Flight Procedures Cover Page	Task Action: FLIGHT CHECK	Task Type: Textual DP	Estimated Chart Date: 06/17/2021	APWS Task ID: EB2AA7CDDF414E7C87B09EBDB63FD131	APWS Project ID: C321DD131C974F448E891991955471E2
Procedure: KS39 ODP AMENDMENT 2B		Enroute: YES	Specialist: Gracey, Dean		Agreement Number:
Airport ID: S39			Airport City: PRINEVILLE		State: OR
Facility ID:	Facility Type:	Flight Inspection Remark Type: New FC Slot			
<p><b>Procedure Comments:</b>  USED PENDING AIRPORT DATA.  MAGVAR CHANGED FROM 15E TO 14E EPOCH (2025).  RWY NUMBER CHANGED FROM 10/28 TO 11/29.  CONTACT ALLAN WILL AJV-A423 (405) 954-6103.</p> <p>05/10/2021: THIS IS AN UPDATED COPY OF THE FORM  DEVELOPED ON 01/20/2021.  1. UPDATED ACTUAL EFFECTIVE DATE TO 06/17/2021.  2. UPDATED REQUIRED EFFECTIVE DATE FROM ROUTINE TO HARD.</p>

## PRINEVILLE (S39)

### TAKEOFF MINIMUMS AND (OBSTACLE) DEPARTURE PROCEDURES

**Prineville Airport – Prineville, OR**

KS39 PRINEVILLE,  
OR  
TEXTUAL ODP  
Rwy 11  
1:500,000

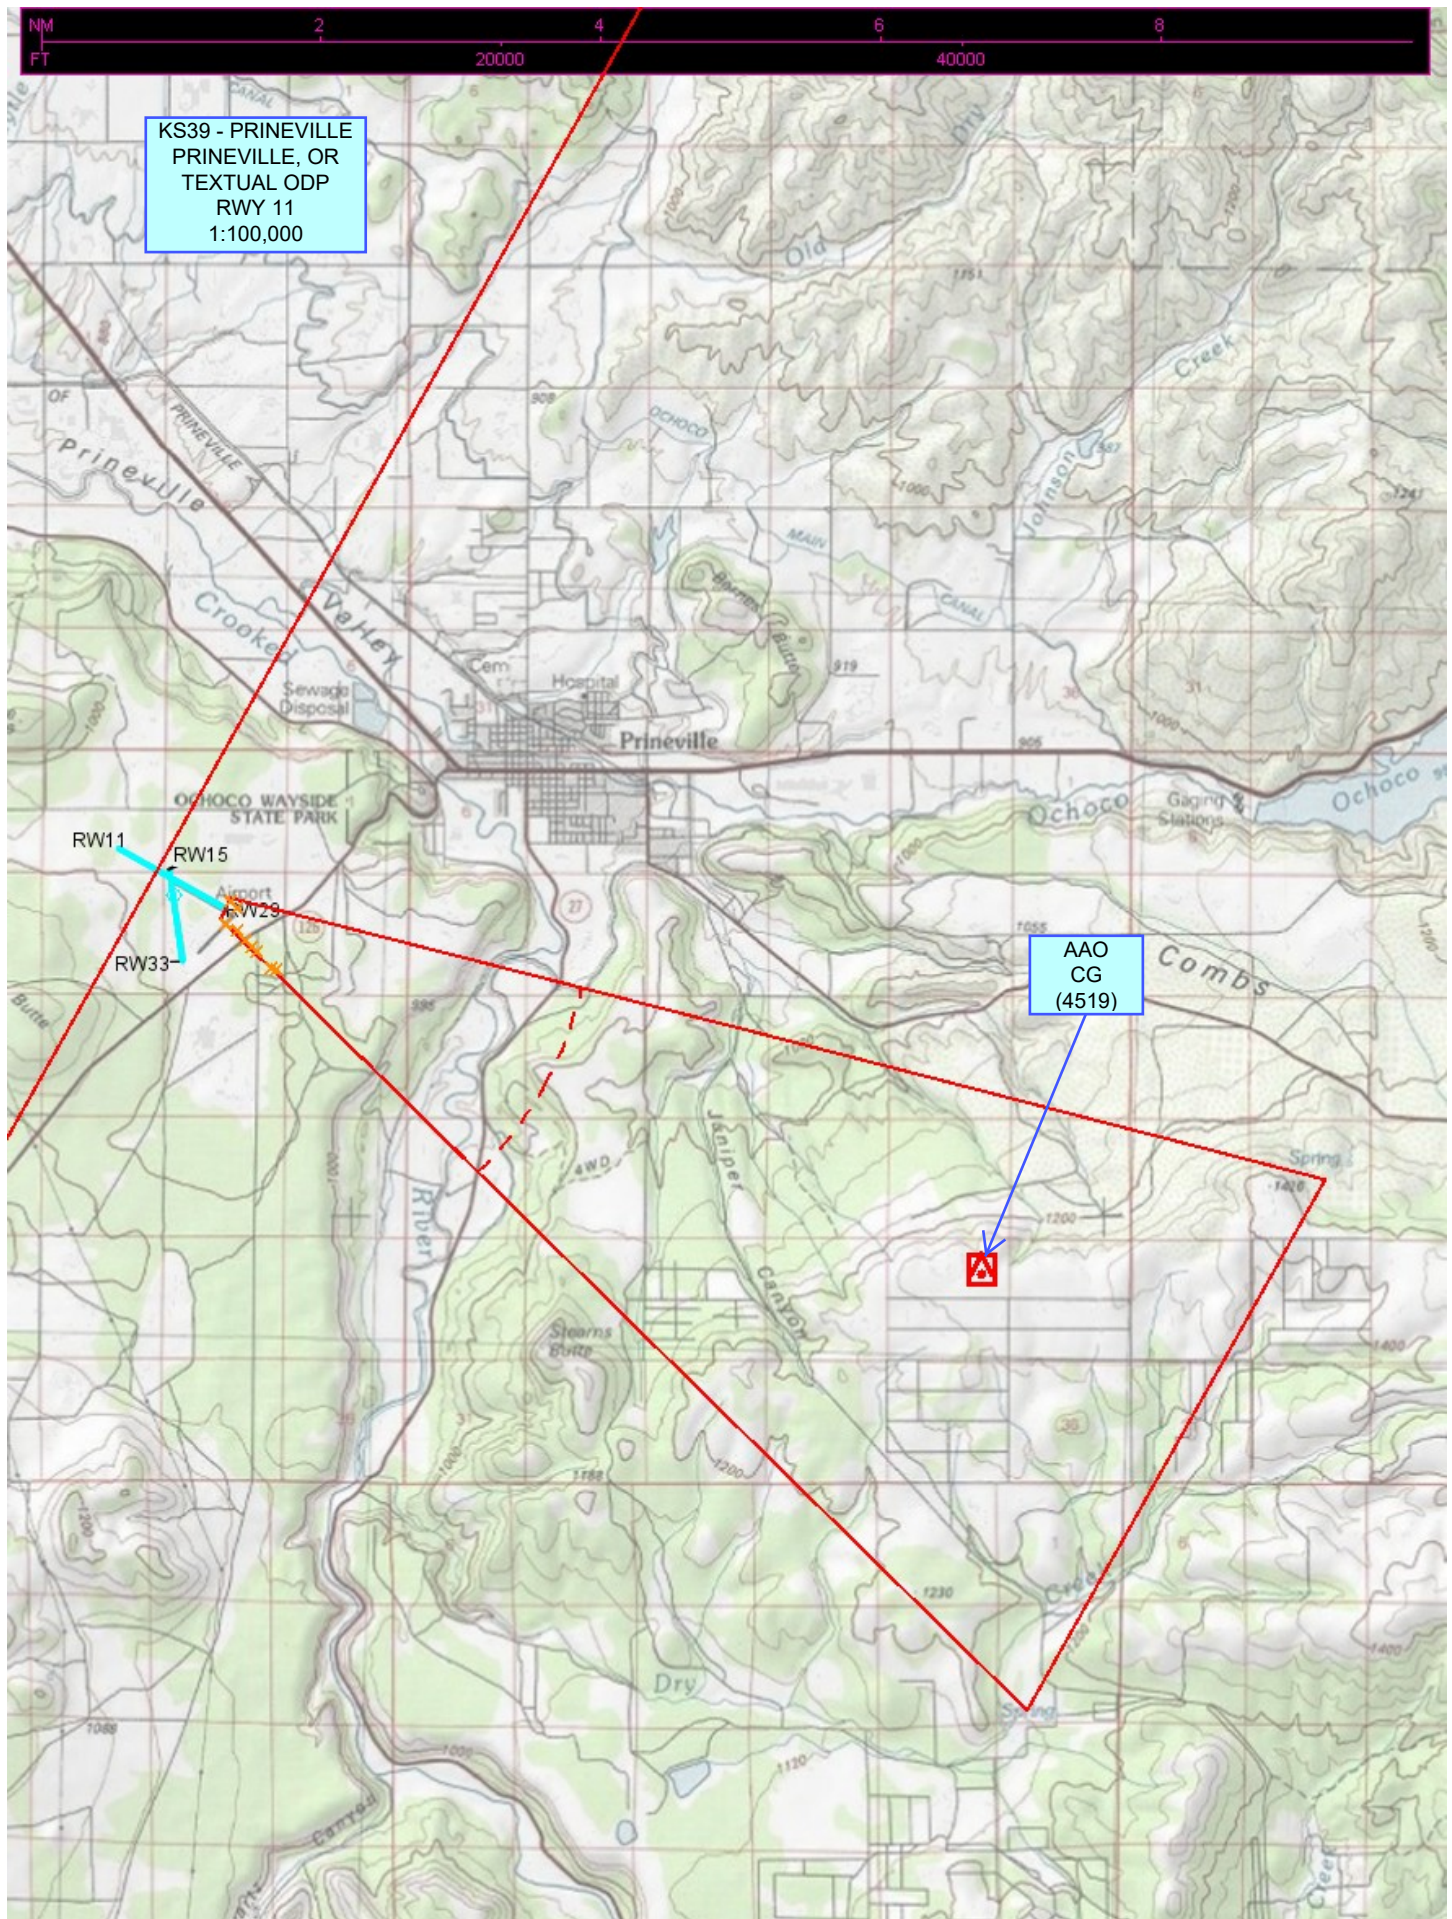
RWYS WILL BE RENUMBERED FROM 10/28 TO 11/29.

The procedures and runways at Prineville Airport (S39) must be revised as a result of a Magnetic Variation (MagVar) update at the airport from 15°E to 14°E. The MagVar update requires runway (RWY) renumbering; RWY 10 would become RWY 11, and RWY 28 would become RWY 29. Runway renumbering and MagVar updates would necessitate revisions to all headings on all procedures. In addition, RWY 29 would have the runway threshold relocated, shortening the runway by 346 feet (ft).
